THE BID DOCUMENTS, CONDITIONS OF CONTRACT, DRAWINGS AND SPECIFICATIONS ARE HEREBY AMENDED, AS FOLLOWS:

END OF ADDENDUM 6

Drawing Title
**Ground & Second Floor
Plan - Renovation**

For
Algonquin and Lakeshore Catholic District
School Board
Drawing Title
Reflected Ceiling Plan
Second Floor
Date: 04-25-2024 Project No: 22026 Drawing No: A702
Drawn by: AB, JJ Scale: As indicated

Date: 04-25-2024 Project No: 22026 Drawing No: A204
Drawn by: AB, JJ
Scale: As indicated

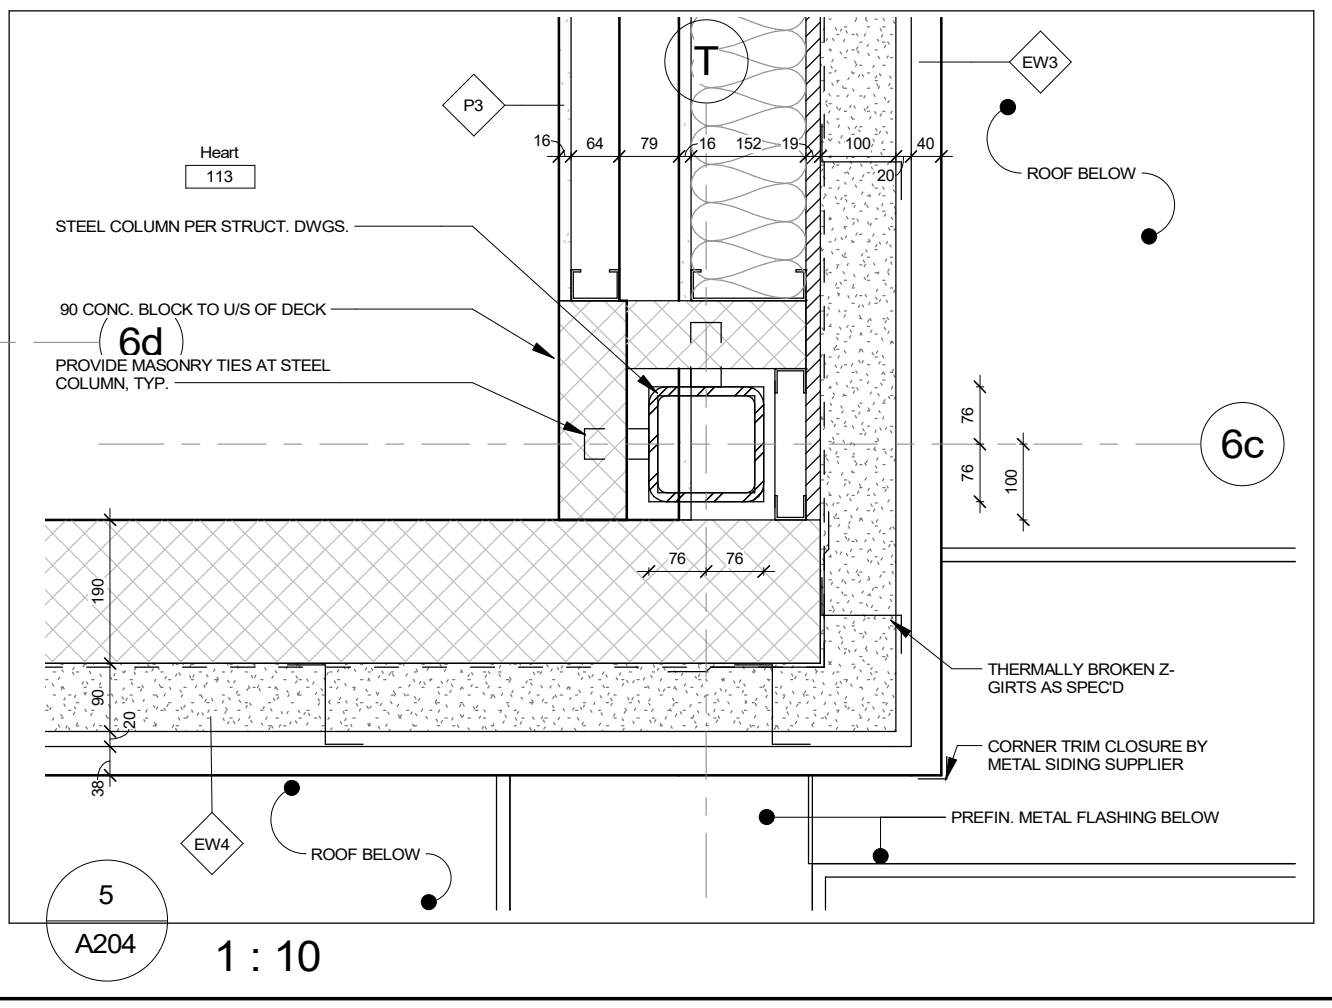
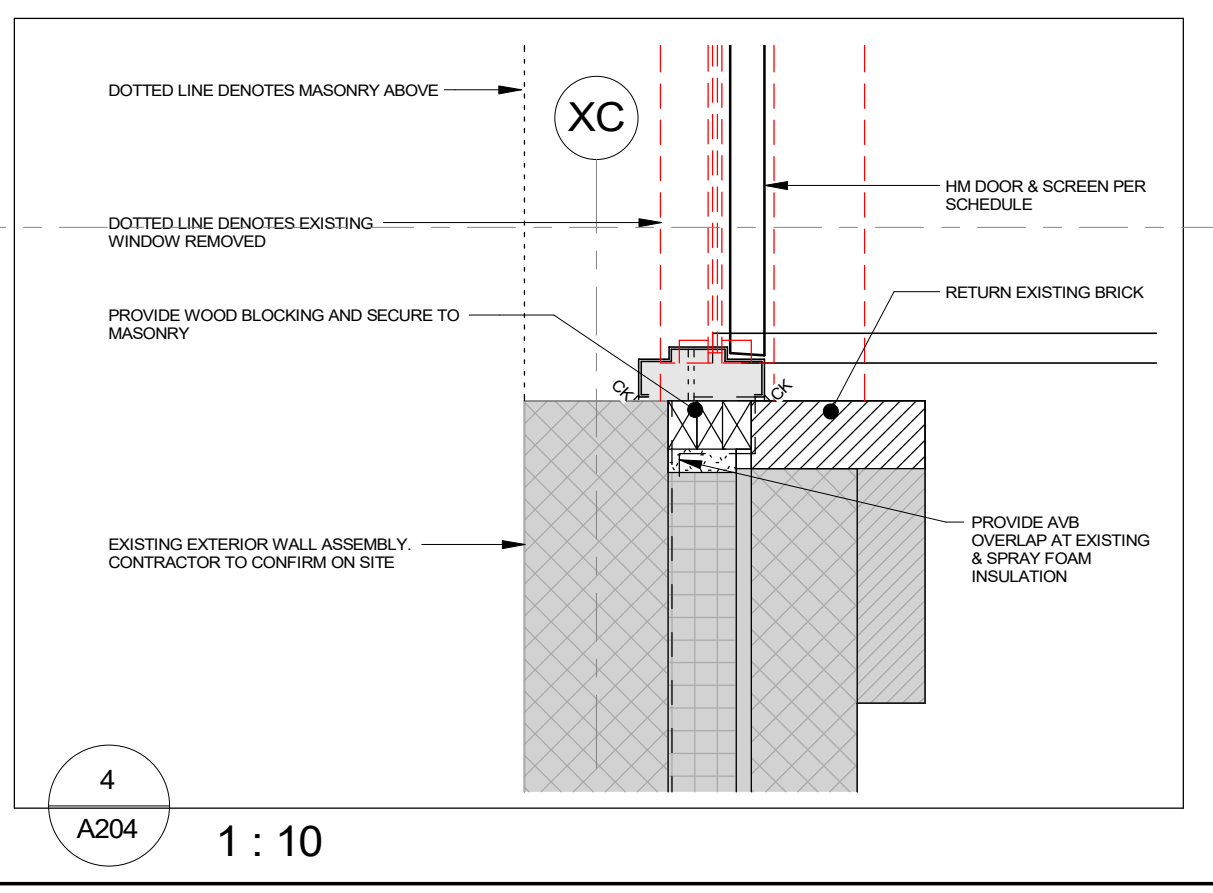
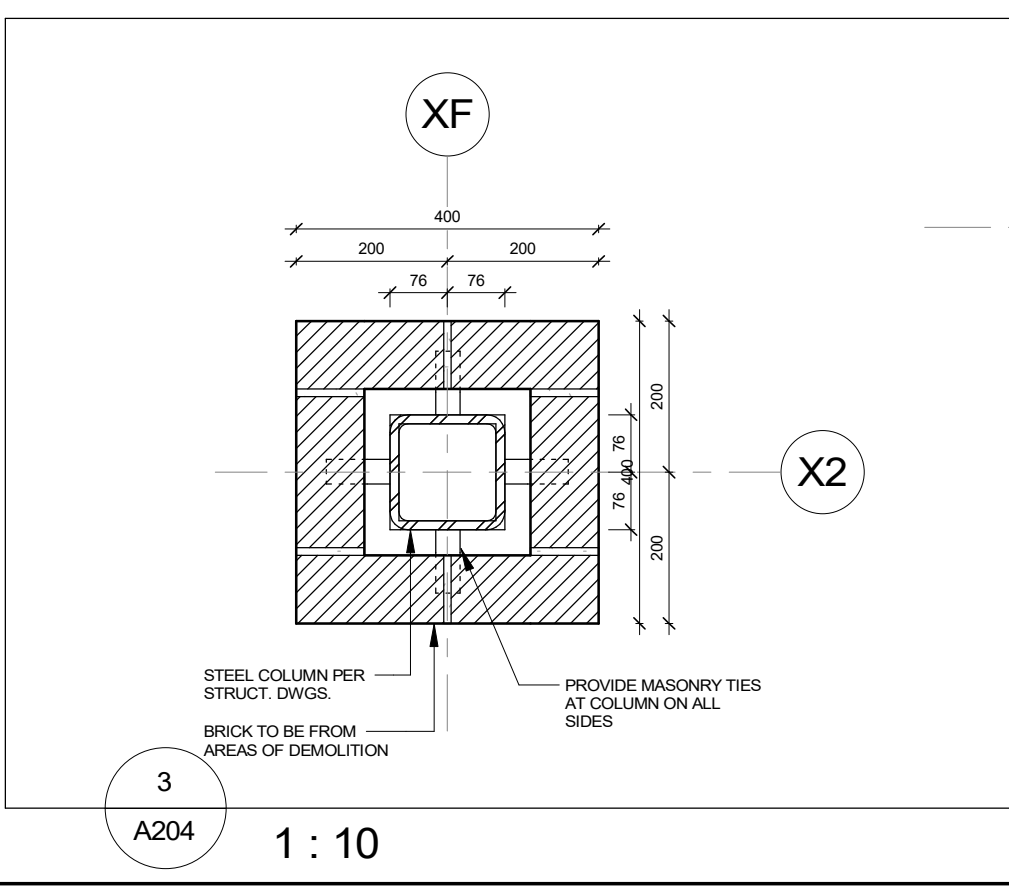
- A204 – Ground & Second Floor Plan – Renovation
 - Additional door to be provided in Ex. Mechanical Room
- A205 – Roof Plan
 - Additional door to be provided in Ex. Mechanical Room
- A301 – Building Elevations
 - Additional door to be provided in Ex. Mechanical Room
- A304 – Window & Interior Screen Elevation
 - Skylight details added.
- A601 – Interior Elevations & Door Schedule
 - Additional door to be provided in Ex. Mechanical Room
- A702 – Reflected Ceiling Plan Second Floor
 - Skylight details added.

1
A702
Level 2 Reflected Ceiling Plan
1 : 100

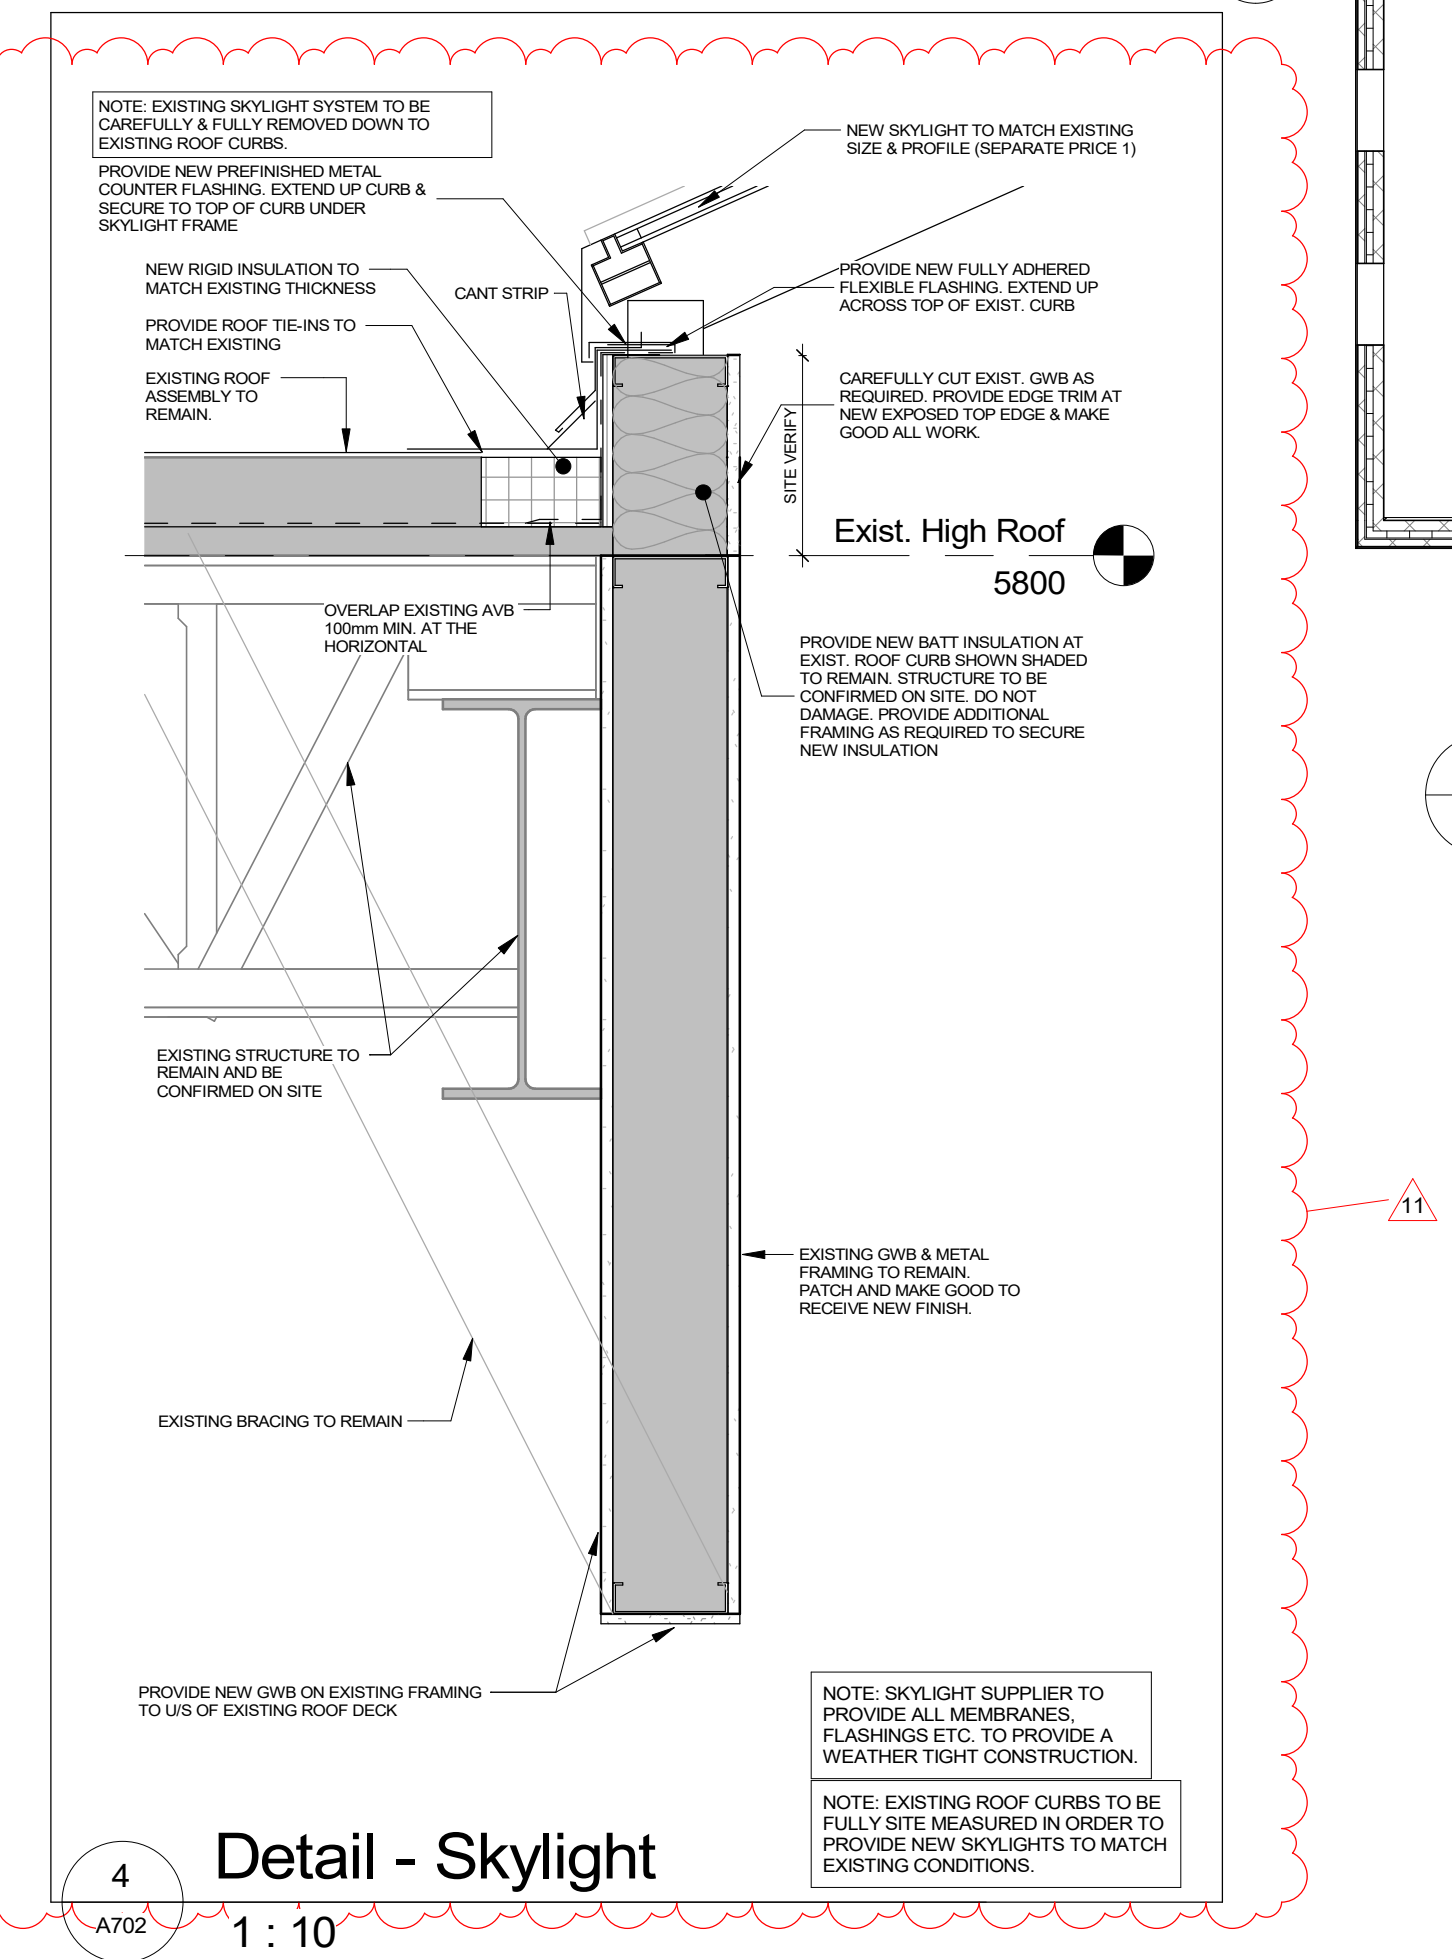
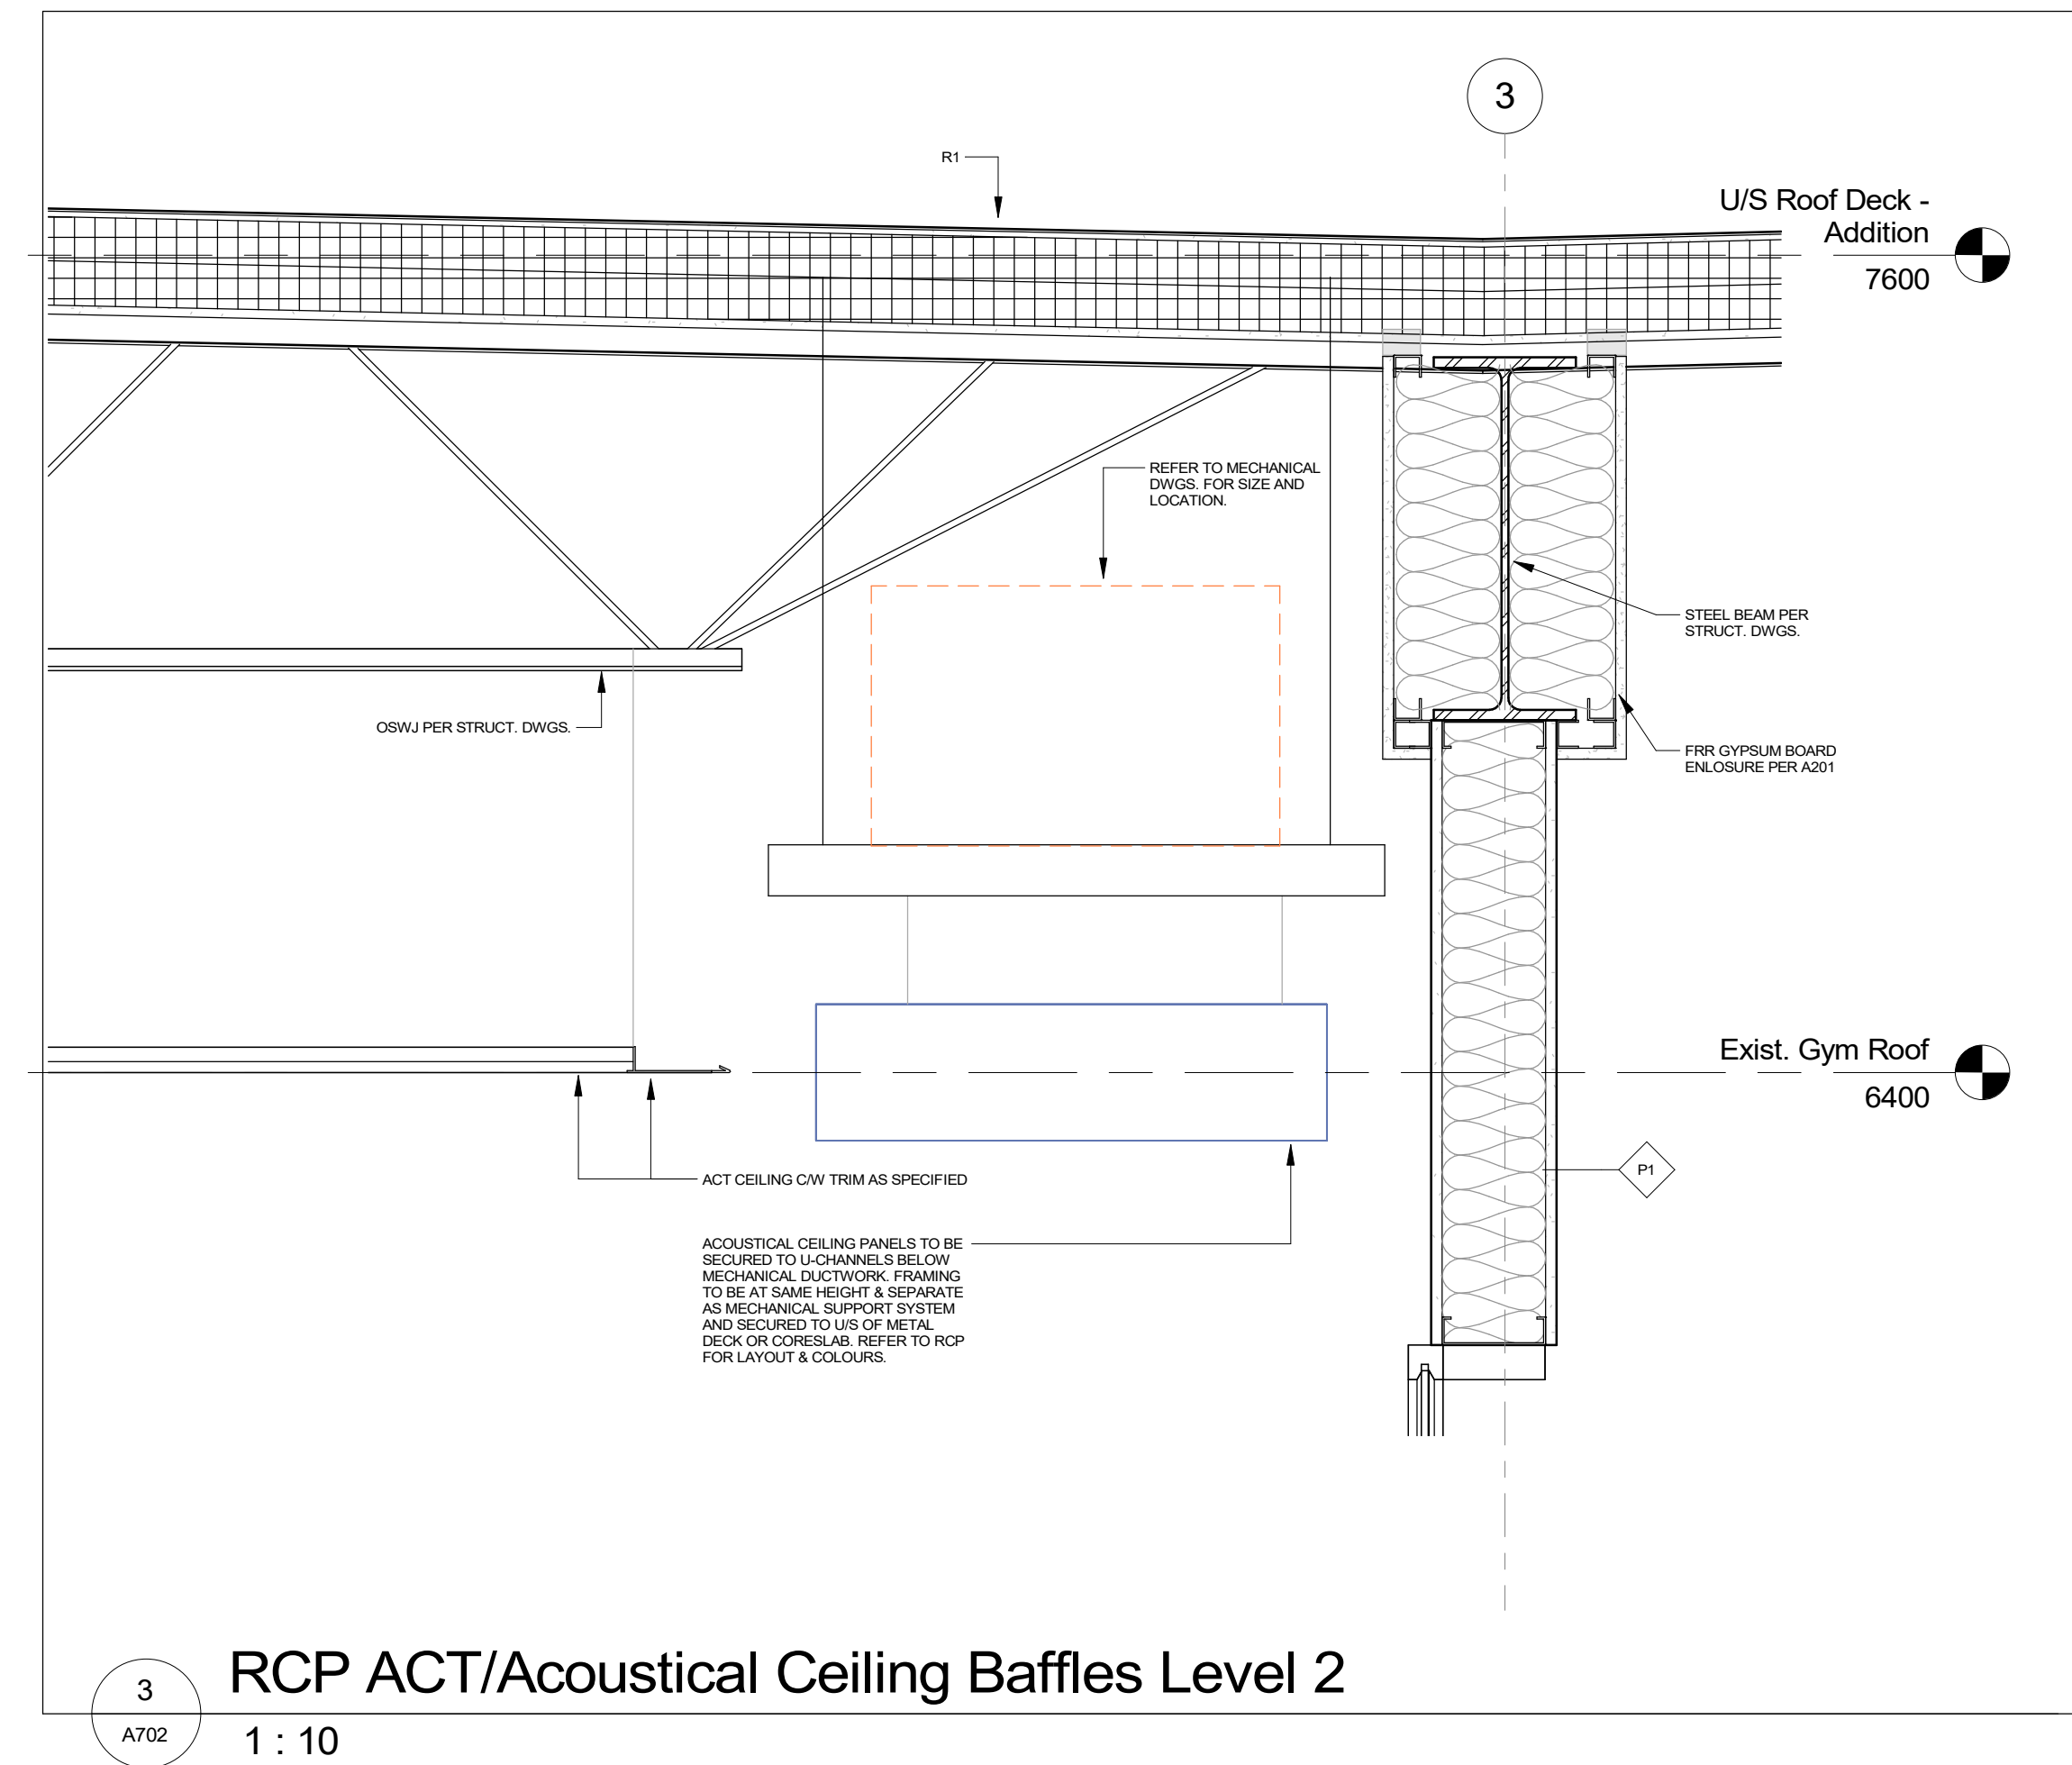
“You have asked for a separate price to replace the existing skylight. Please provide details for this work as nothing has been provided.”

Response: Please refer to architectural details provided per amendment 2.
